**CODE REPORT –  
SITE ACCESSIBILITY REPORT**

The Client is a new construction development on 4.24 acres in Hillsboro, Oregon. The development consists of a three 4 story apartment buildings with a 5-tier open parking structure. The development is a full block project which includes all grading of the site, sidewalks and the street up to the centerline of the adjacent public streets. The scope of this compliance report is limited to site accessibility from centerline of adjacent public rights-of-way to the building entrances.

### Curb Ramps

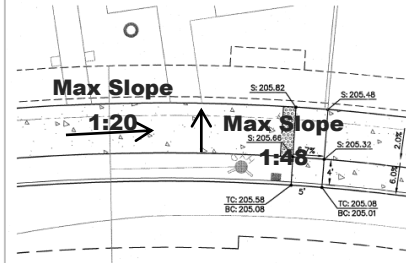
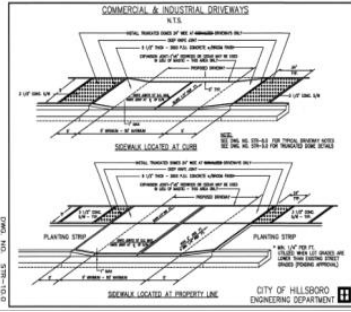
- The review of permit documents has identified the following areas of concern:
- The counterslope of the road surface at the curb ramps must be 1:20 or less per ICC A117.1, Section 406.2. This is not indicated on the drawings and needs to be confirmed. See page 5.

Accessibility Component	Documentation	Provided Compliance
<p>Locations on accessible routes as site arrival points per OSSC §1104.1.</p>		<p>Provided at all street intersections.</p>
<p>Counter slopes of adjoining gutters and road surfaces immediately adjacent to the curb ramp shall not be steeper than 1:20 per ICC A117.1 § 406.2.</p>		<p>Not noted on offsite drawings.</p>

### Accessible Parking

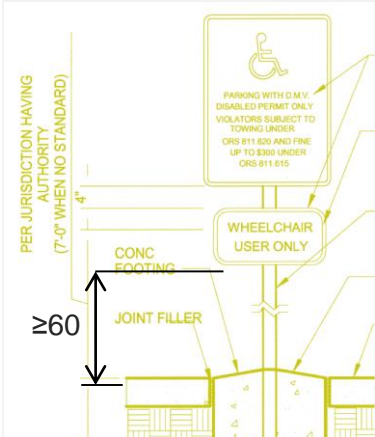
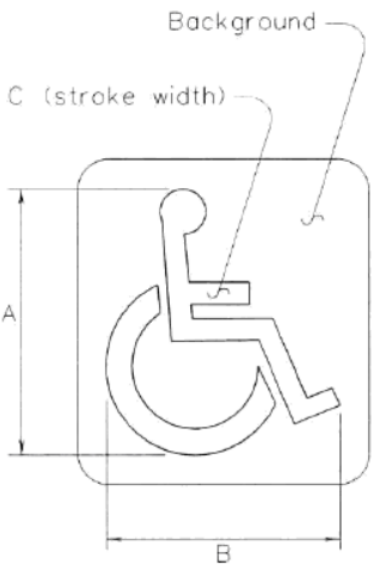
Accessibility Component	Documentation	Provided Compliance
Signage at wheel chair only accessible spaces shall conform to chapter 11 Figure 7 per 2010 OSSC 1106.7.2.		Sign text does not comply with State of Oregon requirements.
Signs shall be 60 inches minimum above the floor of the parking space, measured to the bottom of the sign per 2010 OSSC 1106.7.2.		Dimension required not shown in design documents.
Pavement marking at accessible spaces shall conform to Figure 1 of Chapter 11 OSSC per 2010 OSSC 1106.7.2.		Pavement marking detail is not provided in design documents.
